Initial assessment of RIIO-GD1 business plans

Supplementary Annex

Reference: 20/12
Publication date: 17/02/12

Figure 3.1: Tier 1 replacement expenditure regression

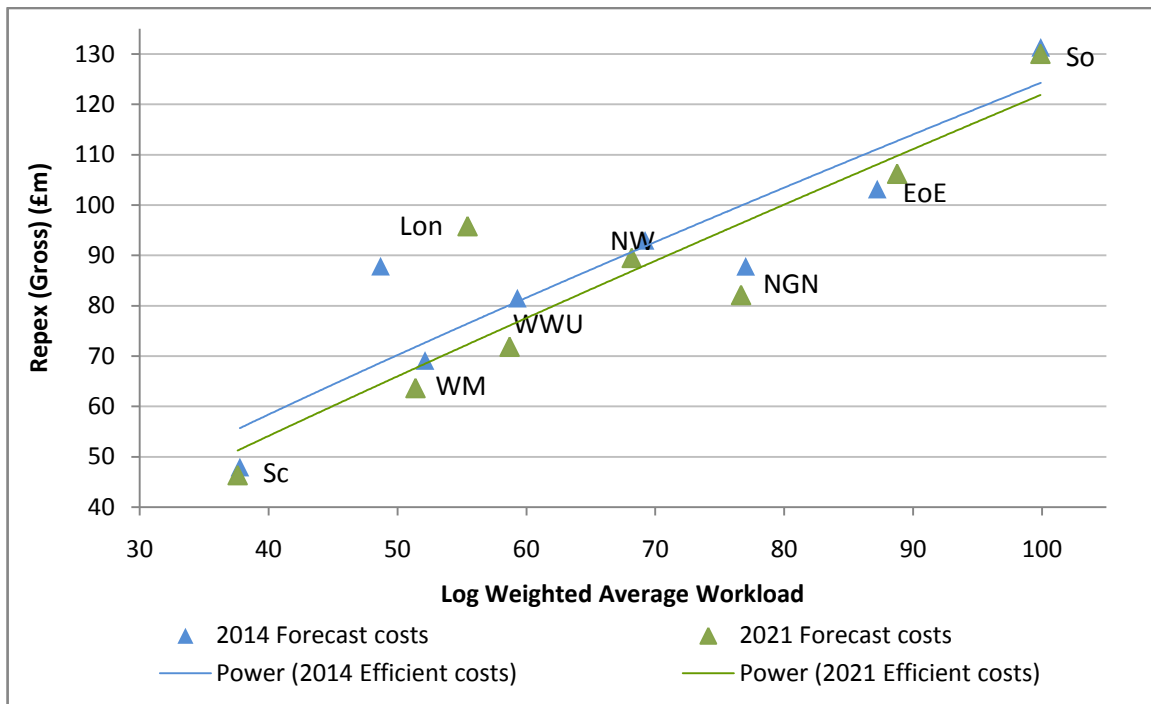
3.37. Figure 3.1 presents a comparative efficiency modelling for tier 1 repex. The regression analysis illustrates the relative efficiency of the GDNs' tier 1 repex relative to the workload, and in Table 3.4 the corresponding efficiency rankings in the first and last year of RIIO-GD1.

3.38. The regression analysis does not take into account all the regional labour and company specific factors proposed by the GDNs, which we are still developing. We therefore recognise that it does not assess GDNs' costs on a comparable basis. However, it presents an indicative view of one of the approaches we plan to use for our comparative assessment of GDNs' RIIO-GD1 forecast costs.
